CORNERSTONE FAMILY PRACTICE logo and address: 1411 SOUTH POTOMAC STREET, SUITE 360, AURORA, COLORADO 80012. (For Tenant Improvement Permit Only)

City of Aurora Building Division logo and contact information: Project: Cornerstone Family Practice, Address: 1411 S. POTOMAC ST UNIT 360, Construction Type: IIB-SPK, RSN: 1212616, Permit: 2017 1305821.

City of Aurora Building Division logo and contact information: City of Aurora Building Division, Reviewed for Code Compliance, Approved as Noted: John Eckert, Date: Jun 08, 2017, 2015 INTERNATIONAL CODES & 2014 NEC.

THIRD FLOOR - OCCUPANCY AND EGRESS PLAN  
SCALE: 3/16"=1'-0"

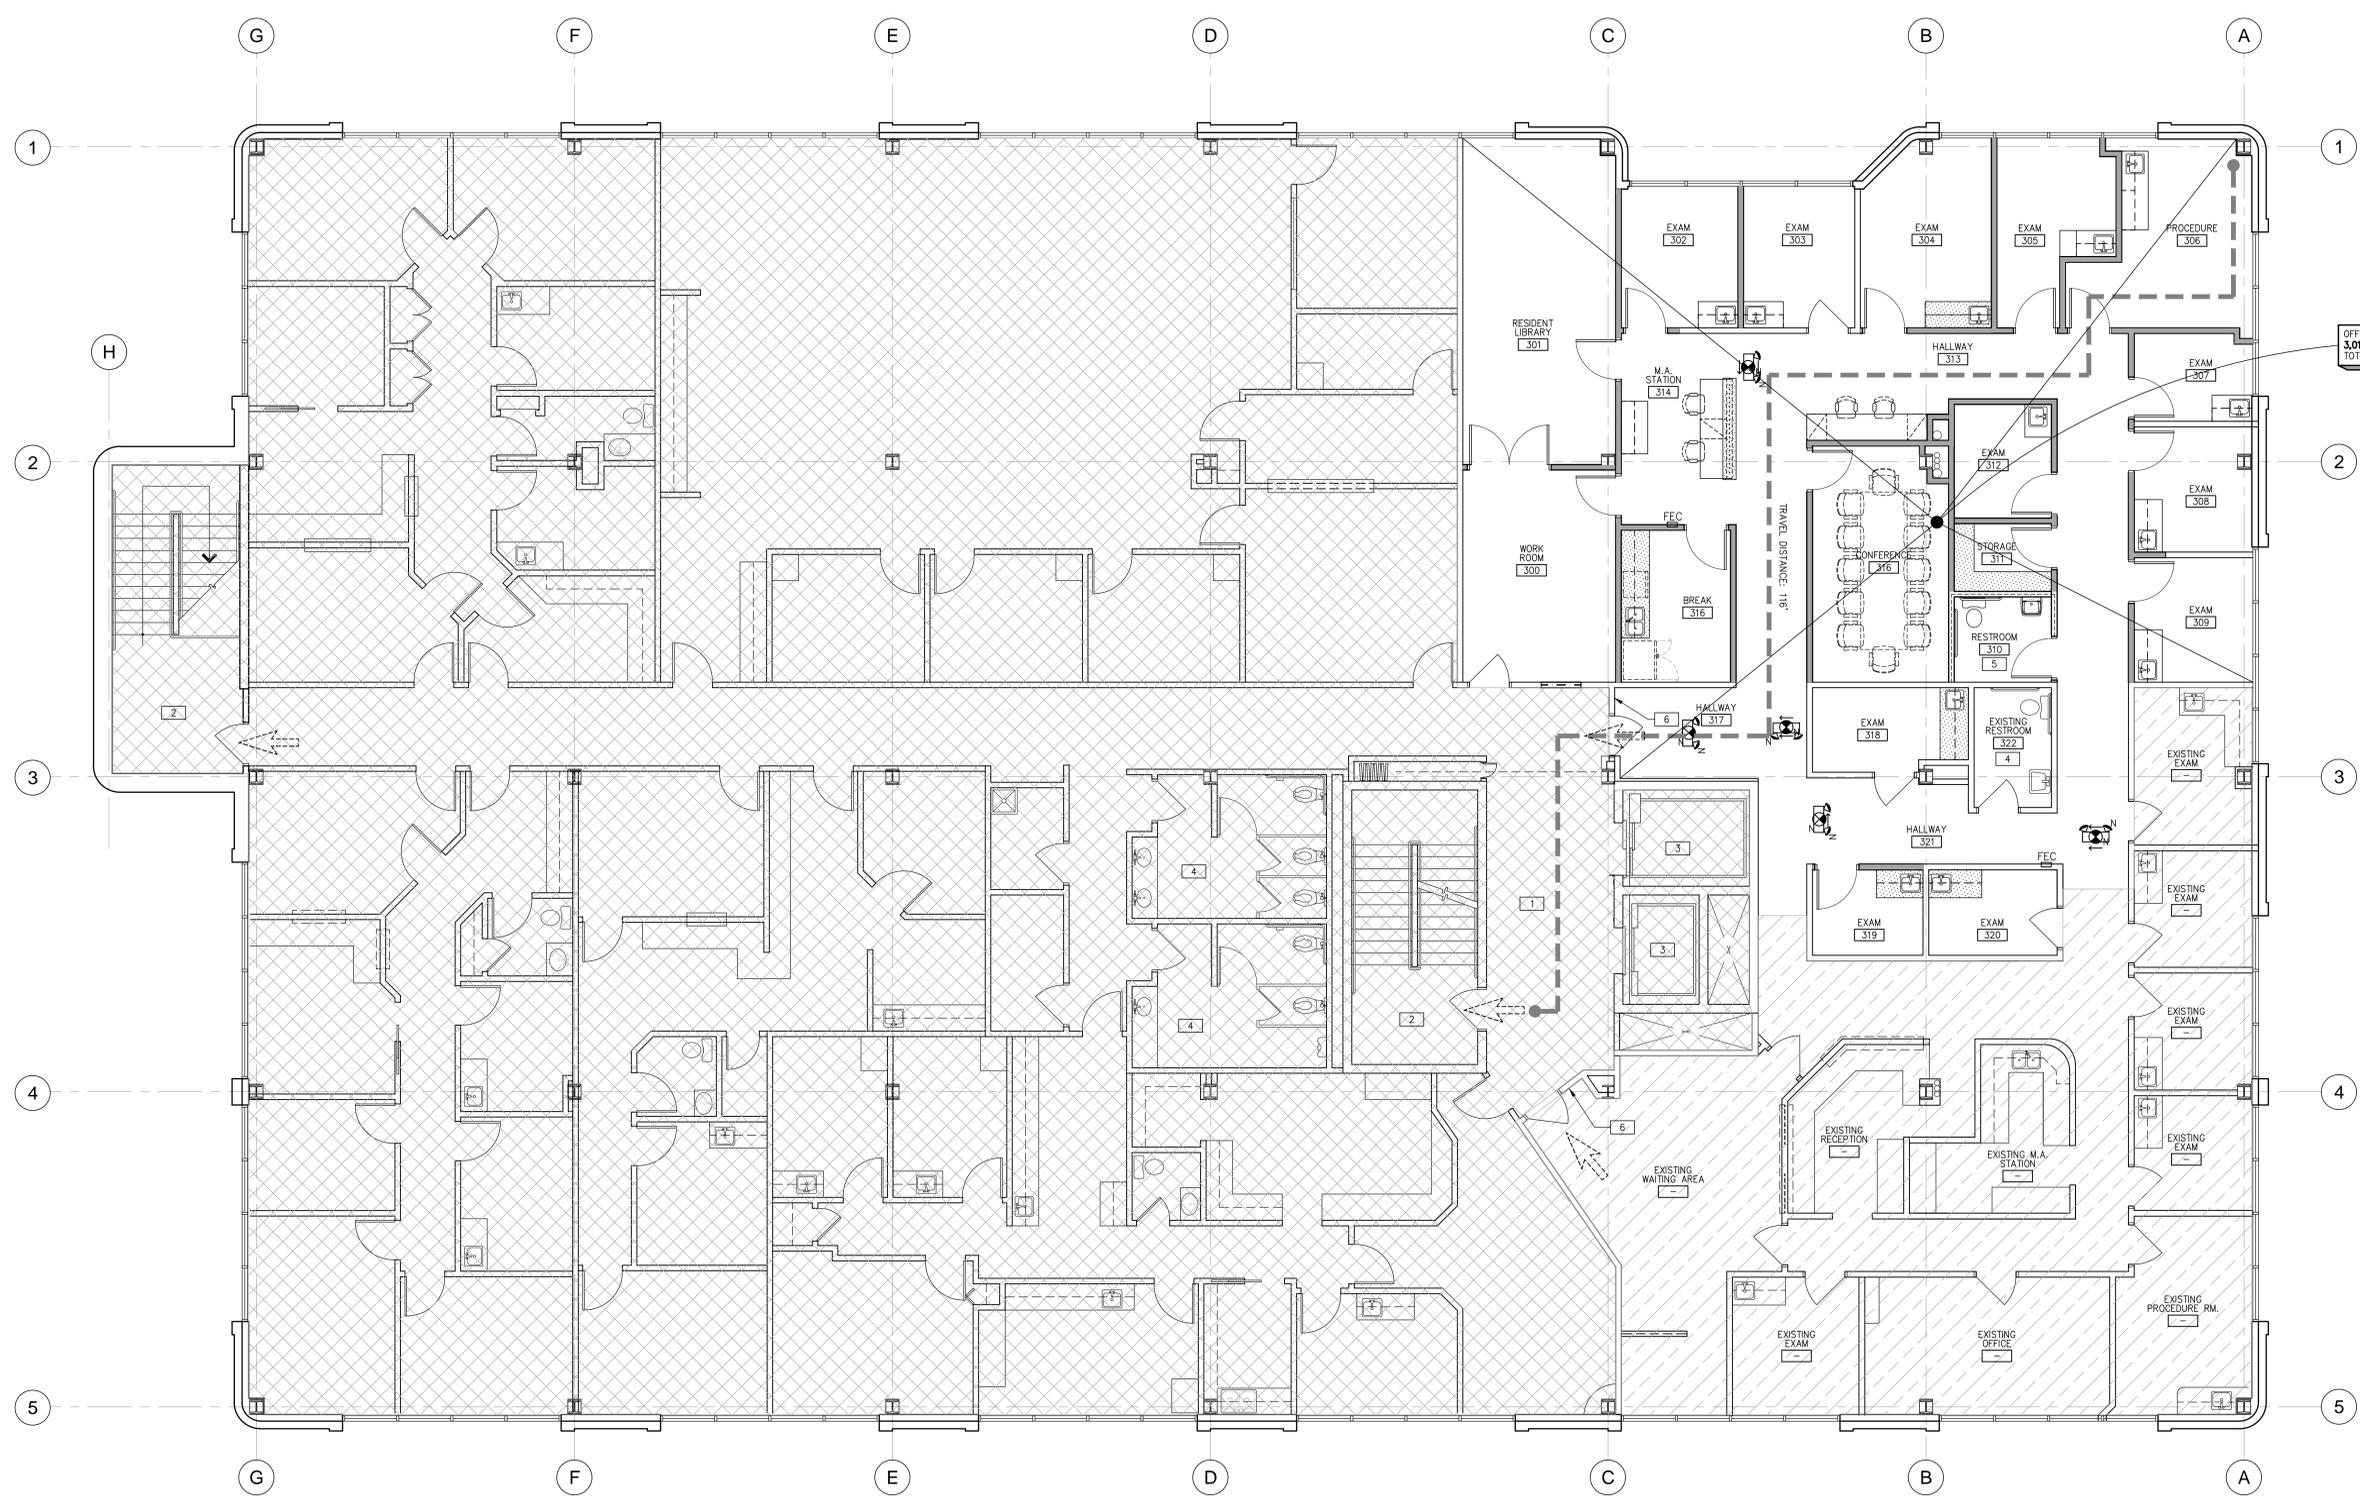
Provide a sign stating "EXIT" in raised, visual characters and braille adjacent to each door in an area of refuge, an exterior area for assisted rescue, an exit stairway or ramp, an exit passageway and the exit discharge. **2015 IBC 1013.4**

**RESTROOM MOUNTING HEIGHTS**

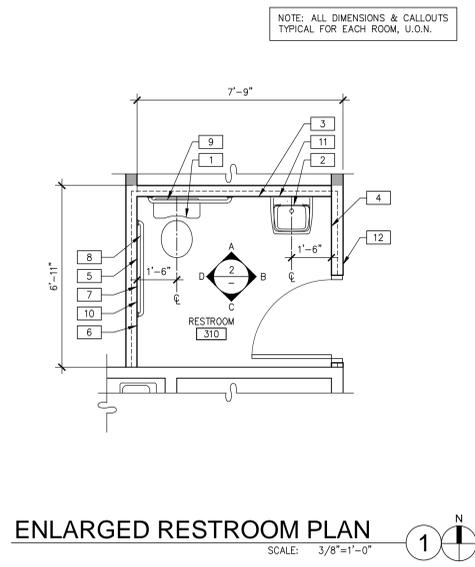
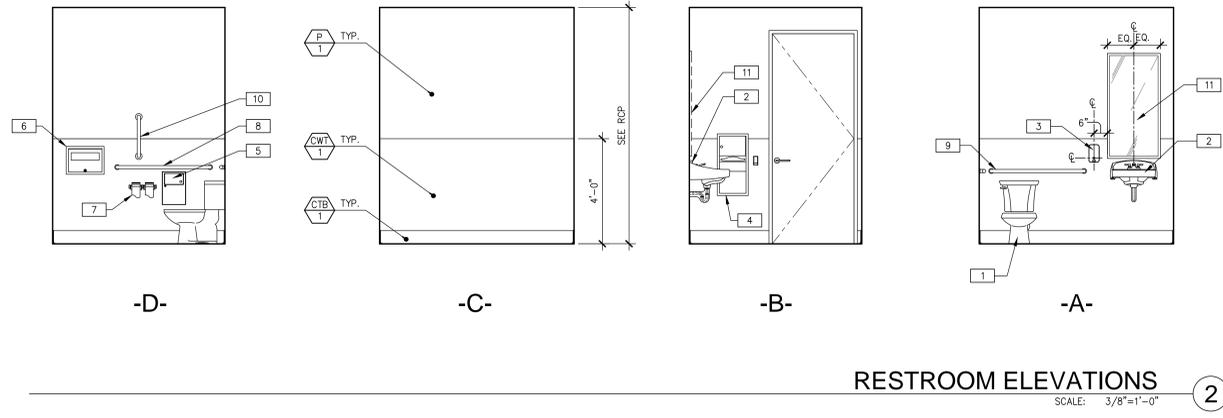
This plan was reviewed for adopted codes and **NOT** for compliance with **ADA** or **FHA** accessibility requirements. Contact 800-949-4232 (**ADA**) and 303-894-7822 x 325 (**FHA**) for federal accessibility requirements that apply to your project.

**2 LIGHTING PLAN**  
SCALE: 3/16" = 1'-0"  
Project North

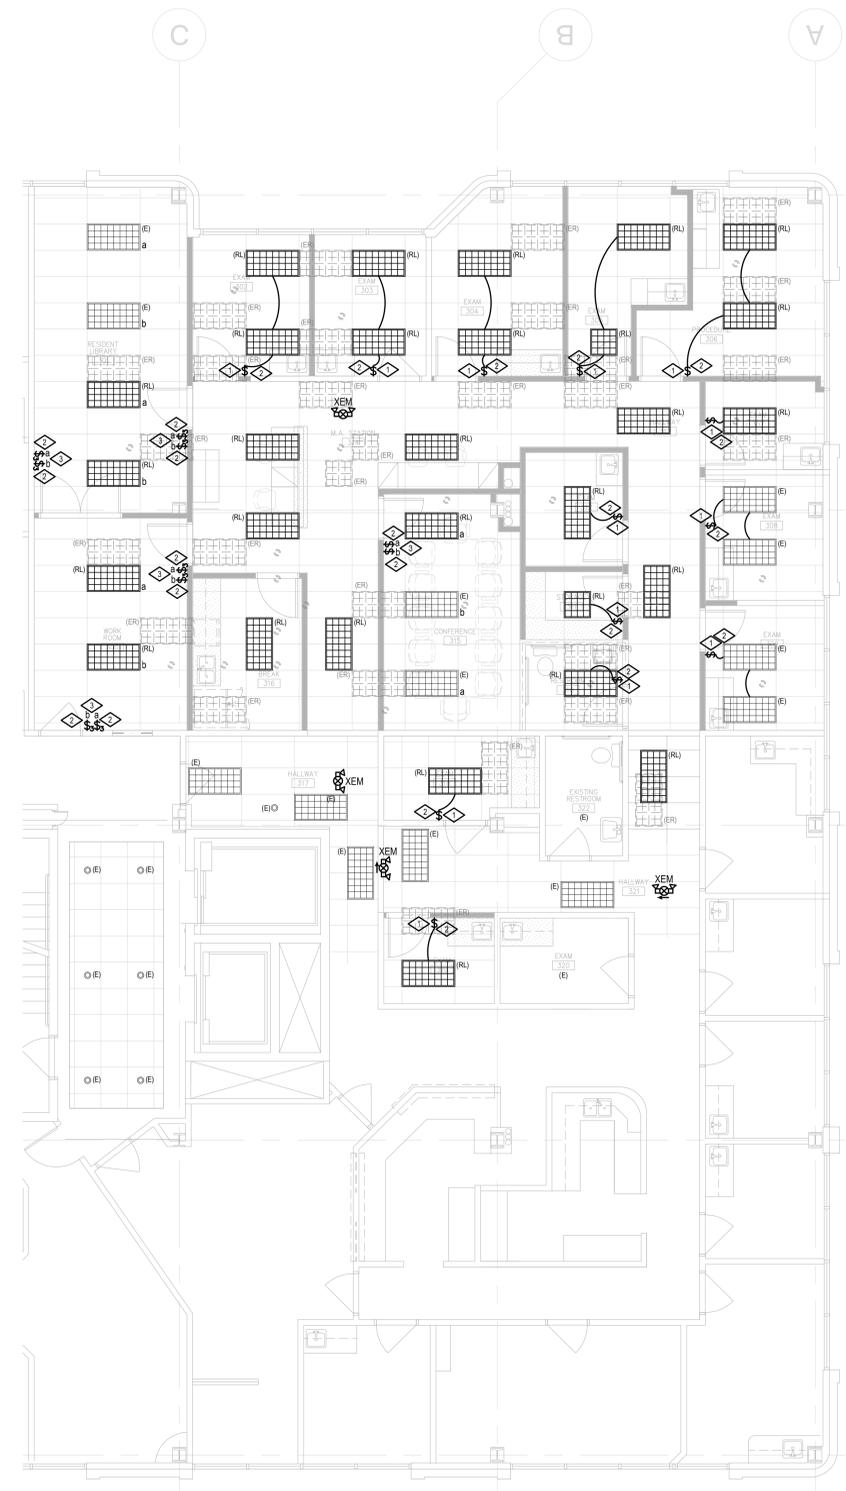
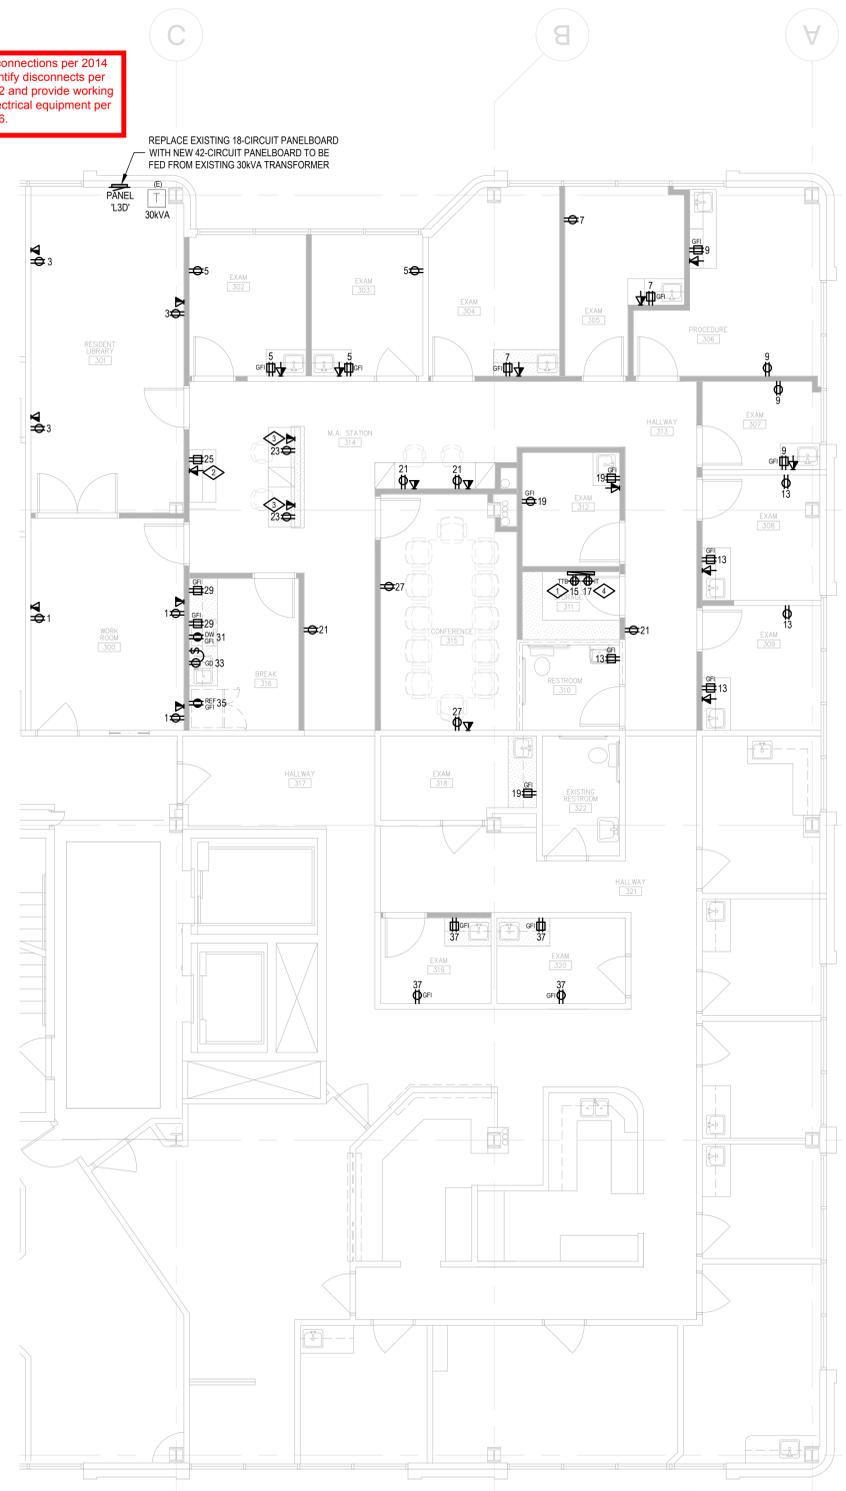
Legibly identify each breaker or switch for it's use or purpose on the circuit directory in the panel/switchboard per 2014 NEC 408.4.

**MECHANICAL FLOORPLAN**  
1/4"=1'-0"  
1 M2.0

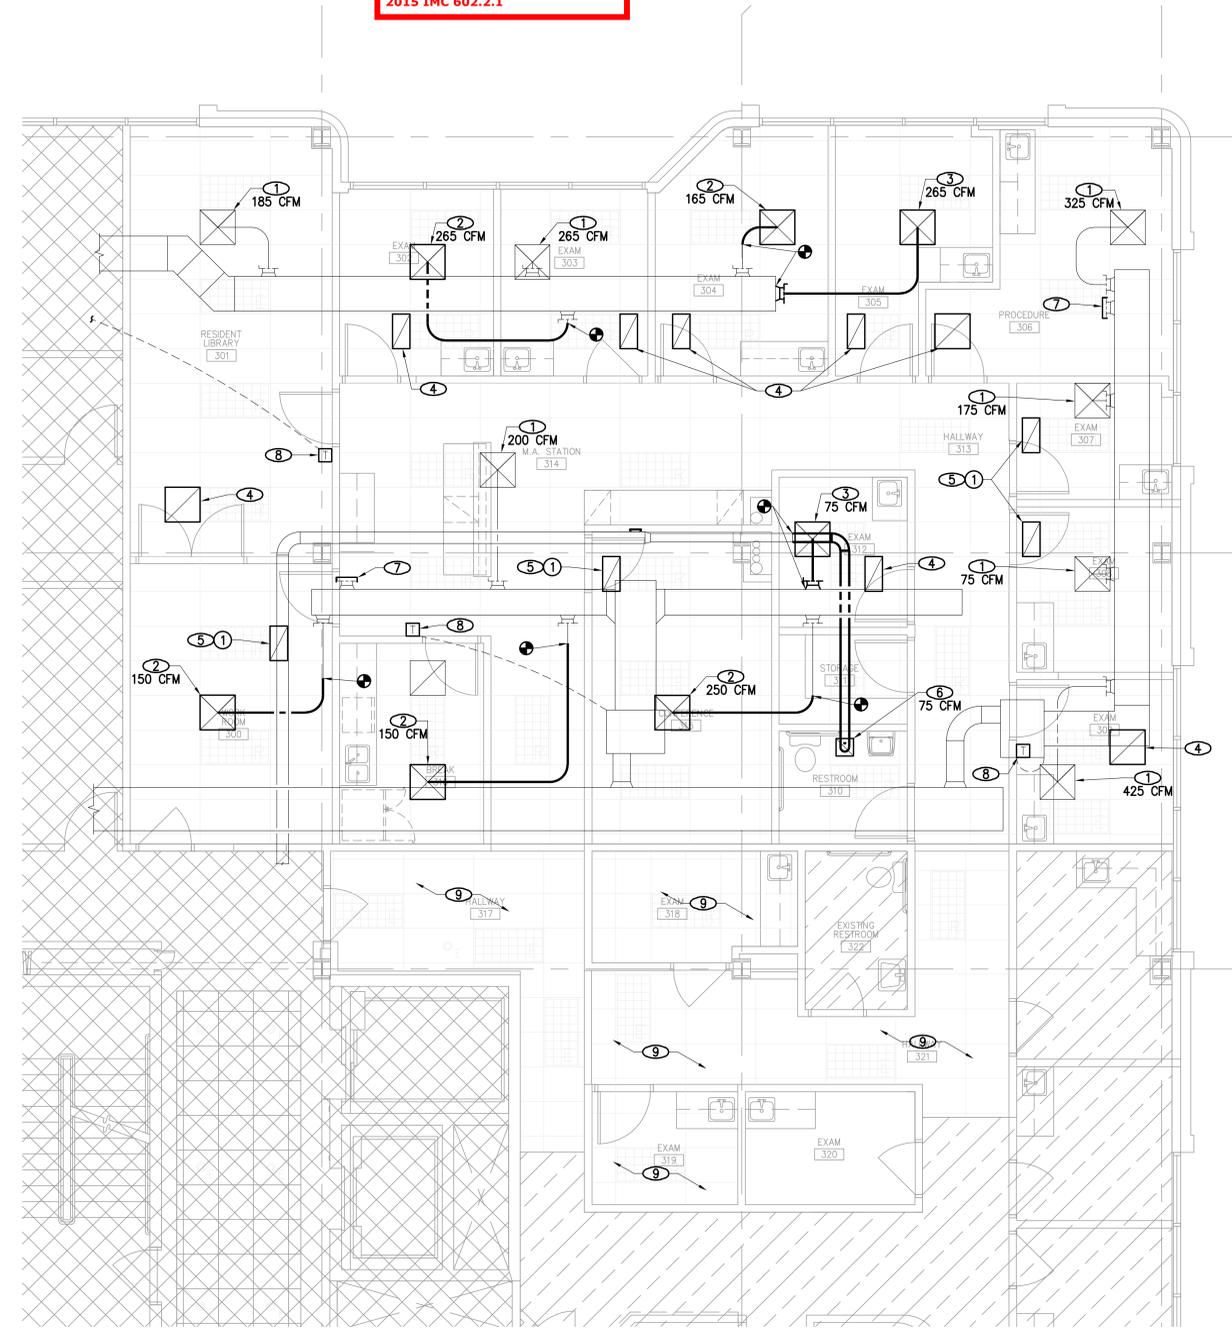
Provide proof of a flame spread less than 25 and a smoke development less than 50 for any material used in a plenum.  
2015 IMC 602.2.1

Heating system shall be capable of maintaining 68 degrees F a 3'0" above the floor.  
2015 IMC 309, IRC 303.9 and IBC 1204.1
